AGENDA

Planning Committee Meeting to be held
at Darebin Civic Centre,
350 High Street Preston
on Monday, 14 May 2018
at 6.00pm.

5.1 APPLICATION FOR PLANNING PERMIT 386-392 Bell Street Preston

PROJECT NO: 16016
 PROJECT: 386 - 392 Bell Street Preston

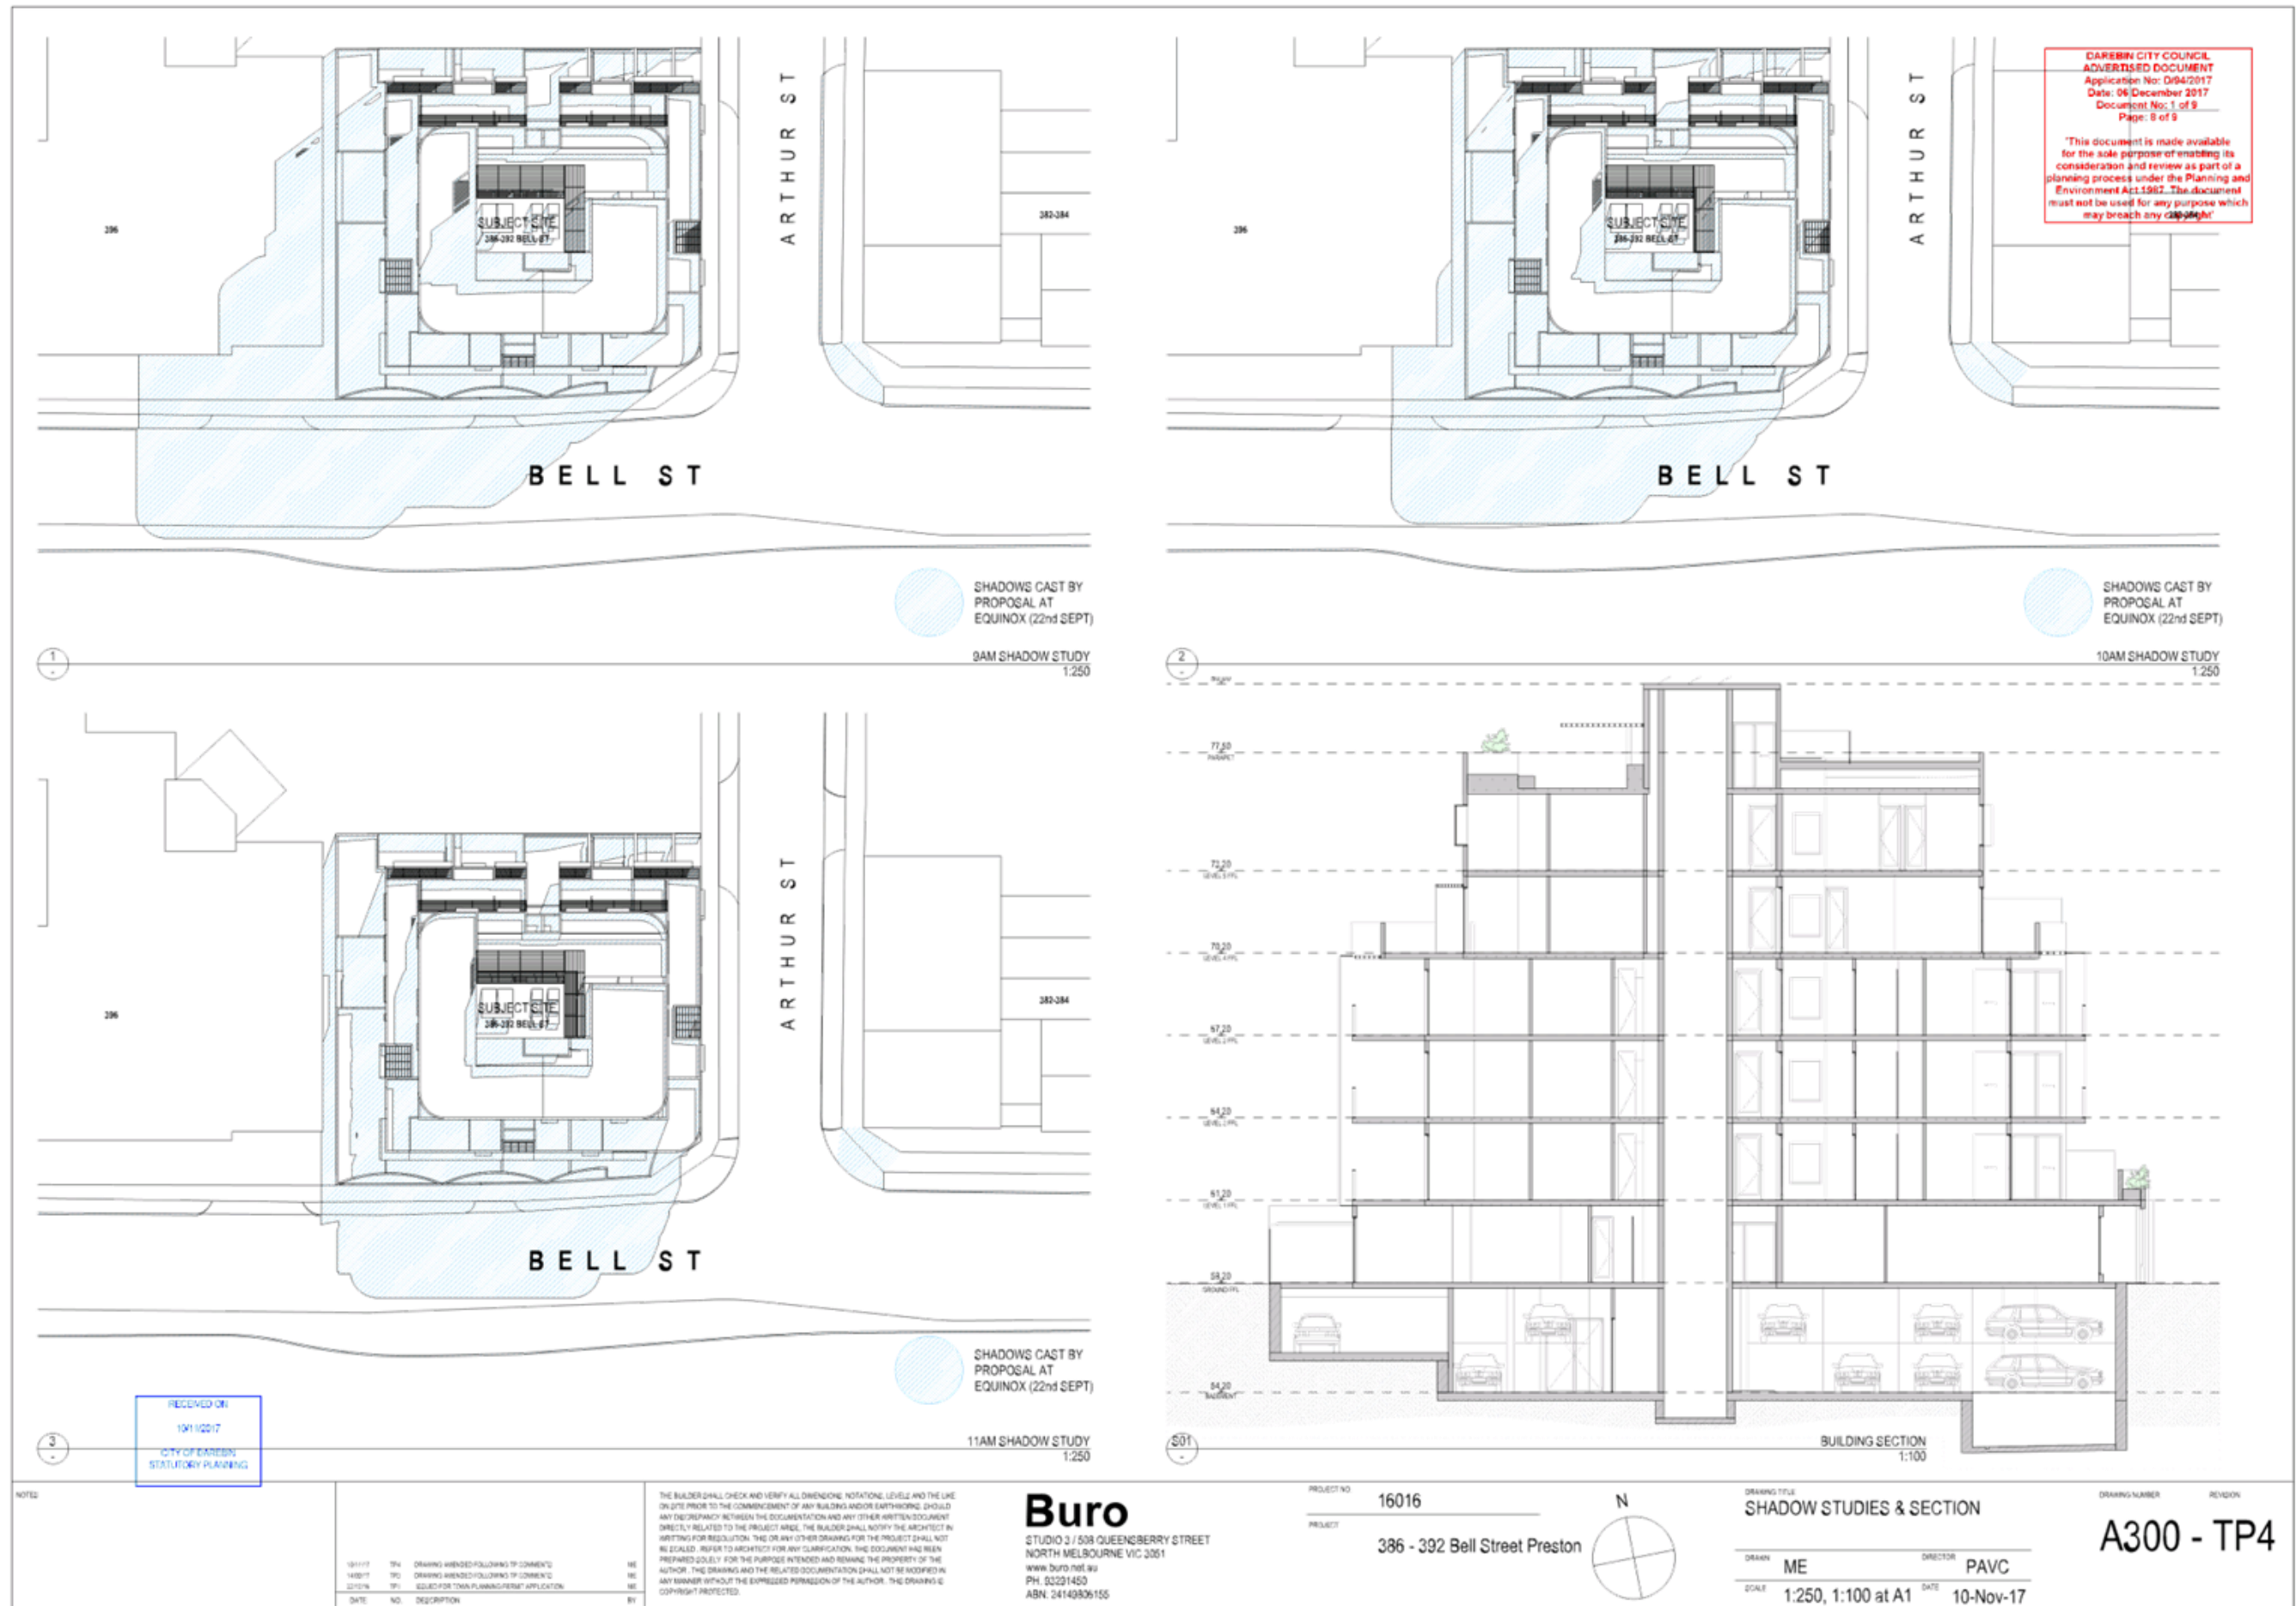
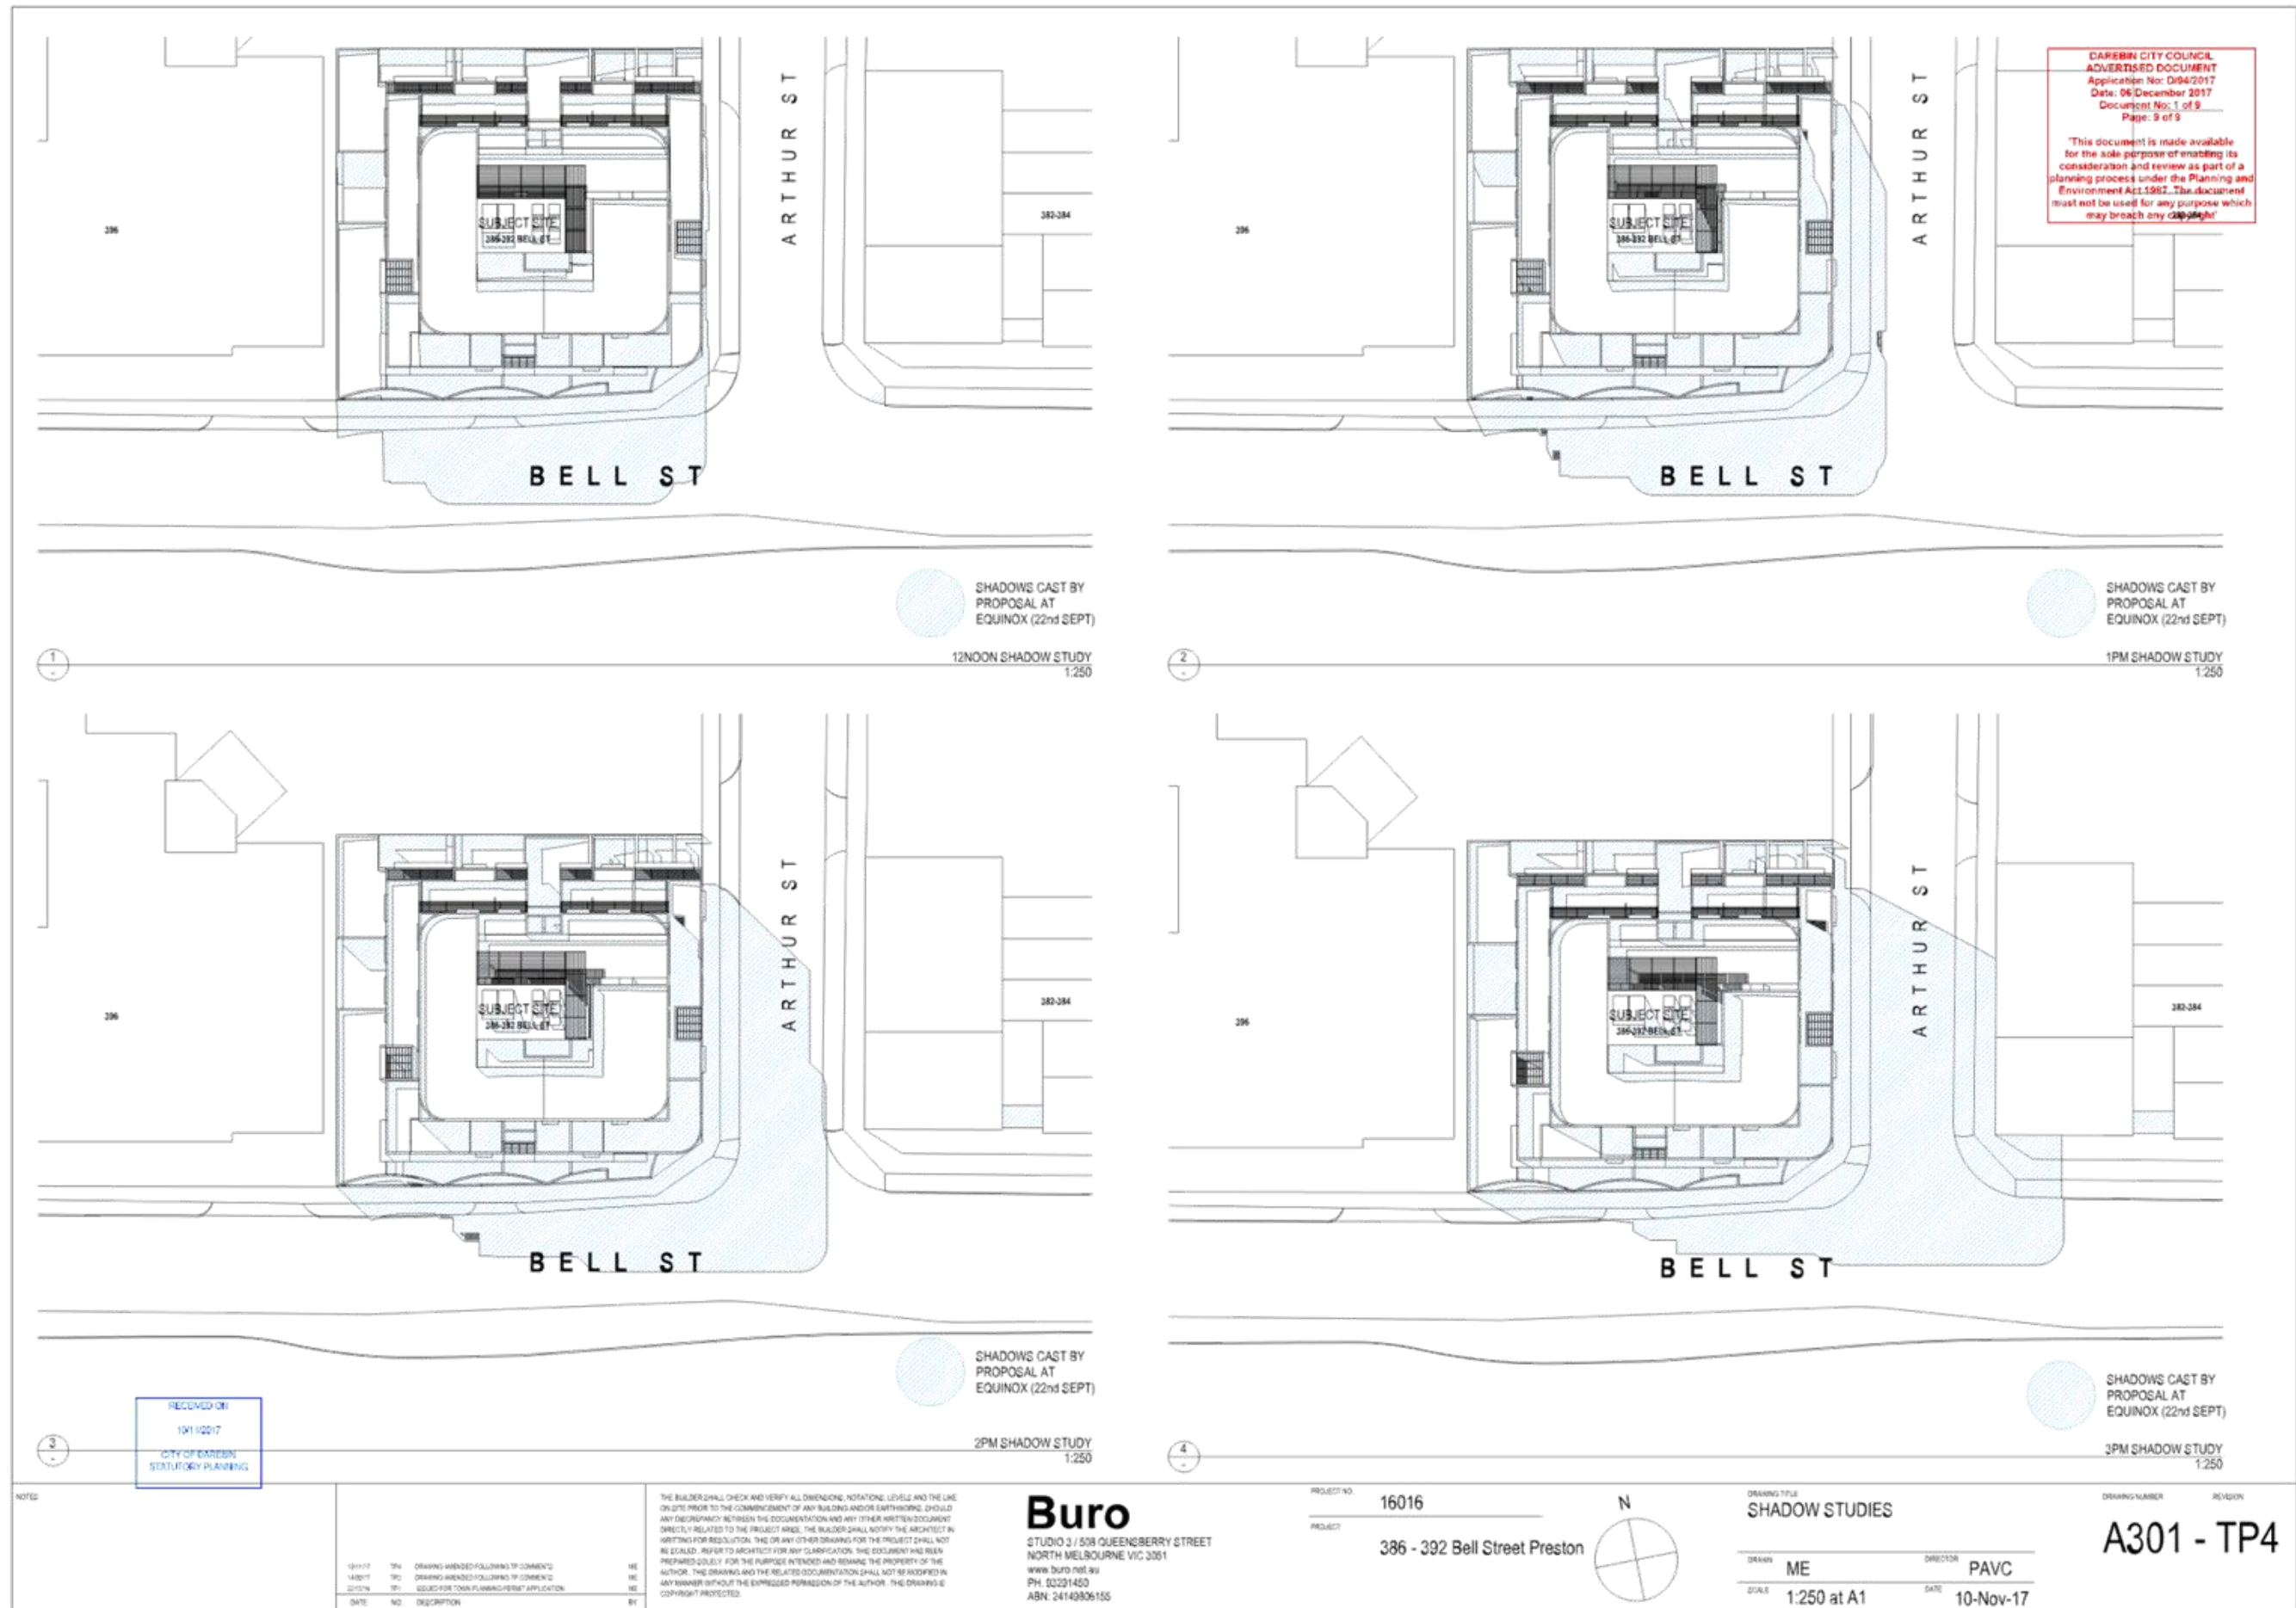
1. Before the development starts, amended plans to the satisfaction of the Responsible Authority must be submitted to, and approved by, the Responsible Authority. The plans must be drawn to scale with dimensions and must be generally in accordance with the plans submitted with the application (identified as drawings A101 – TP5, A102 – TP4, A103 – TP4, A104 – TP4, A200 – TP4 and A300 – TP4 dated November 2017 and prepared by Buro Architects) but modified to show:

- c) All bicycle parking spaces dimensioned in accordance with Australian Standard 2890.3:2015.
 - d) The length of the 1:8 transition increased to 2.6 metres at the ramp grade change from 1:4 to flat or a ground clearance assessment to the satisfaction of the responsible authority.

- e) The proposed Car Stacker Systems (Wohr Parklift 450-170 (320) and Wohr Parklift 450-200 (350)) clearly nominated.
 - f) Section plans updated indicating pit depths corresponding to the nominated car stacker system.
